CITY OF ALBUQUERQUE

**RE: Sigma Chi Parking Lot
Grading and Drainage Plan
Engineer's Stamp Date – 8-2-2016
Hydrology File: J15D098**

DRAINAGE AND TRANSPORTATION INFORMATION SHEET (REV 09/2015)

DRAINAGE REPORT

ENGINEER'S SEAL  8/2/16 DAVID SOULE P.E. #14522	NORTH 70' OF LOT 7, 8, 9, BLOCK 4 SIGMA CHI ADDITION	DRAWN BY JDG
	GRADING AND DRAINAGE PLAN	DATE 07-19-2016
 Rio Grande Engineering 1606 CENTRAL AVENUE SE SUITE 201 ALBUQUERQUE, NM 87106 (505) 872-0999	SHEET # 1 OF 1	JOB #

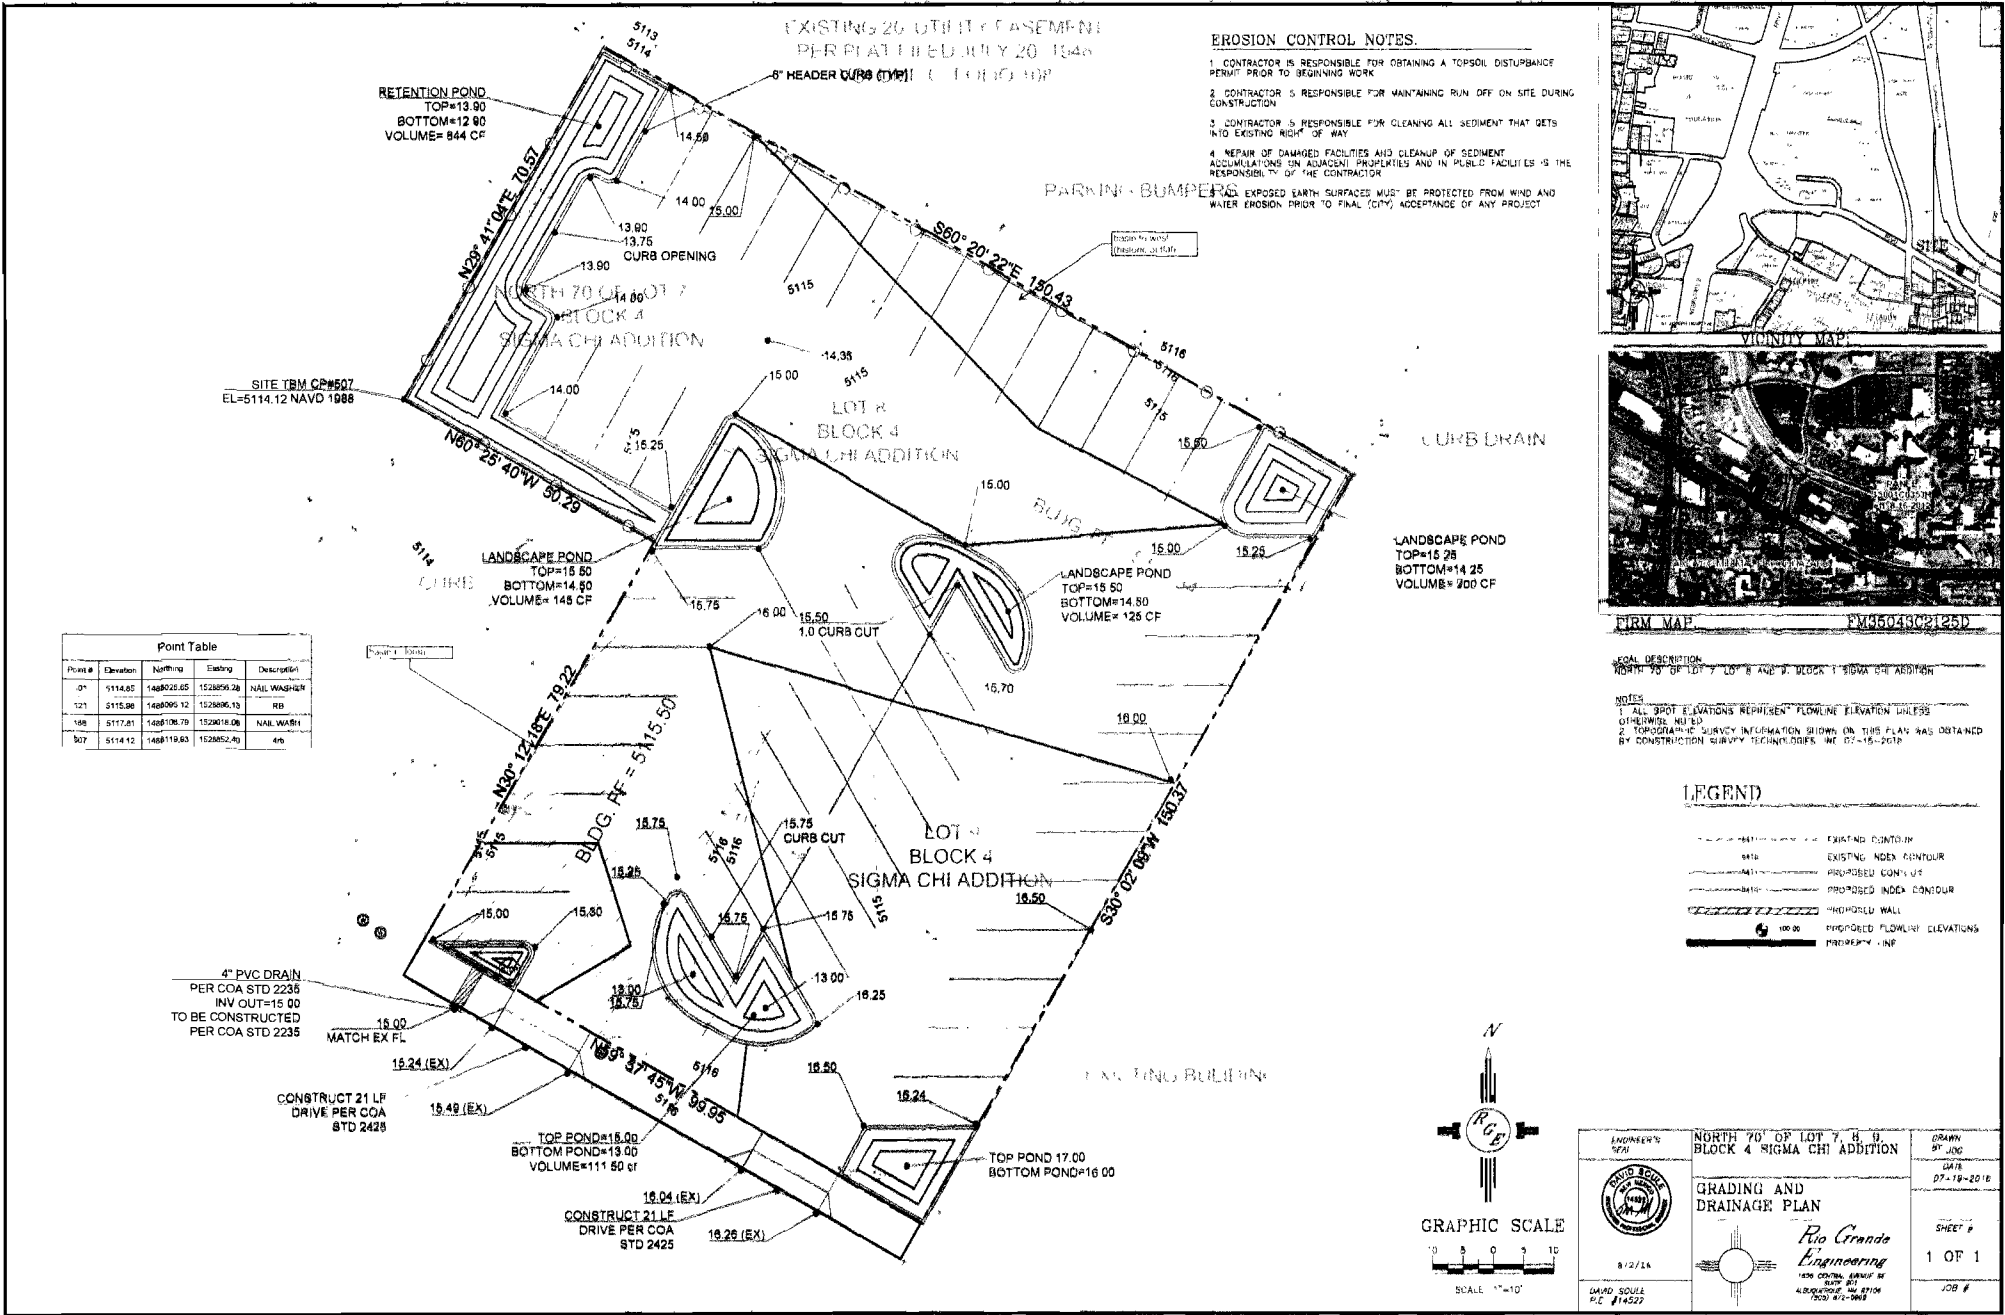
1. Remove the 4" pvc drain that is proposed through the sidewalk, which would require an SO-19 Permit. Instead, a curb cut outlet facing the driveway can provide a spillway for the adjacent pond.
2. Ensure that curb cuts are constructed on all the islands at logical low spots; some are not shown on the plan.
